MEMORANDUM

MONROE COUNTY PLANNING & ENVIRONMENTAL RESOURCES DEPARTMENT

Date: August 18, 2022

Subject: *A REQUEST FOR A MINOR CONDITIONAL USE PERMIT FOR THE DEVELOPMENT OF A MINI STORAGE FACILITY WITH AN ATTACHED DWELLING UNIT DESIGNATED AS EMPLOYEE HOUSING LOCATED AT 92425 OVERSEAS HIGHWAY, TAVERNIER, MILE MARKER 92, AND DESCRIBED AS A PARCEL OF LAND IN SECTION 27, TOWNSHIP 62 SOUTH, RANGE 38 EAST, KEY LARGO, MONROE COUNTY, FLORIDA, HAVING PARCEL IDENTIFICATION NUMBER 00490270-000000 (FILE # 2021-055).*

Figure 14 Articulating Long Depths

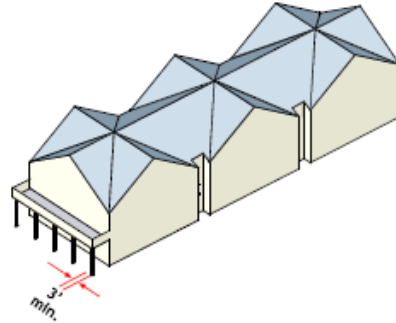
Staff would like to note that the submitted elevation plans do not clearly demonstrate consistency with the maximum building façade as described in the development guidelines; however the submitted site and floor plans do. The rear façade of the building does not include the required insets as referenced above, however this side is screened from US1 by means of a 20 foot wide Class C buffer yard which aids in meeting the intent to break down the apparent massing of buildings greater than 50 feet wide. **Staff is recommending additional plantings be included in this buffer yard to ensure the structure is fully screened from US1.**

- 25 1. Notwithstanding the buffer yard requirements set forth in LDC Article V, the developer
26 must plant an additional six (6) canopy, three (3) understory, and 24, shrubs across the
27 rear façade of the structure in order to provide additional screening from US1.
28
